Access Compliance Report

Public Rights-of-Way

(Curb Ramps)

Intersection ID: 1002822	Main Street: CASTLE_WATCH_AV	Cross Street: N/A	Location: SW
ADA ID: F31A5C12B4A1	Ramp Type: PerpDiag	Initial Pass/Fail: Fail	Overall Compliance: No
Severity Score: 48.75			
Codes/Mitigation Info/Possible Solution		Field Measurements/Component Compliance

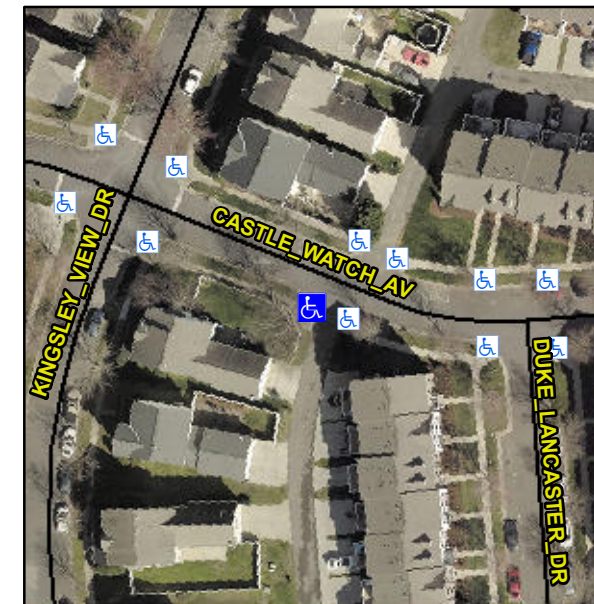
R304.5.1, R304.2.2, R304.5.3

Compliance	Description	Data	Compliance	Description	Data
N/A	Ramp Length (in)	96.0	No	Ramp Slope (%)	8.6
No	Ramp Width (in)	26.0	No	Ramp XSlope (%)	4.9
N/A	Flare Type LT	N/A	N/A	Flare Type RT	N/A
N/A	Flare Slope LT (%)	N/A	N/A	Flare Slope RT (%)	N/A
N/A	Flare Traversable LT?	N/A	N/A	Flare Traversable RT?	N/A
N/A	Landing Length (in)	N/A	N/A	DWS Provided?	N/A
N/A	Landing Width (in)	N/A	N/A	DWS Contrast?	N/A
N/A	Landing Slope (%)	N/A	N/A	DWS Length (in)	N/A
N/A	Landing X Slope (%)	N/A	N/A	DWS Full Width?	N/A
N/A	Landing Curb? (Y/N)	N/A	N/A	DWS Offset (in)	N/A
N/A	Shared Landing?	N/A			
N/A	Gutter Ponding?	N/A	N/A	Gutter Slope (%)	N/A
N/A	Gutter Lip Ht (in)	N/A	N/A	Gutter X Slope (%)	N/A
N/A	Painted X Walk1?	No	N/A	Painted X Walk2?	No
	X Walk 1 Direction	To SE		X Walk 2 Direction	To NE
N/A	X Walk 1 Width (in)	N/A	N/A	X Walk 2 Width (in)	N/A
	X Walk 1 Slope (%)	5.9		X Walk 2 Slope (%)	4.2
	X Walk 1 X Slope (%)	3.9		X Walk 2 X Slope (%)	0.2

Remove & Replace Curb Ramp With Two New Directional Ramps or Equivalent.
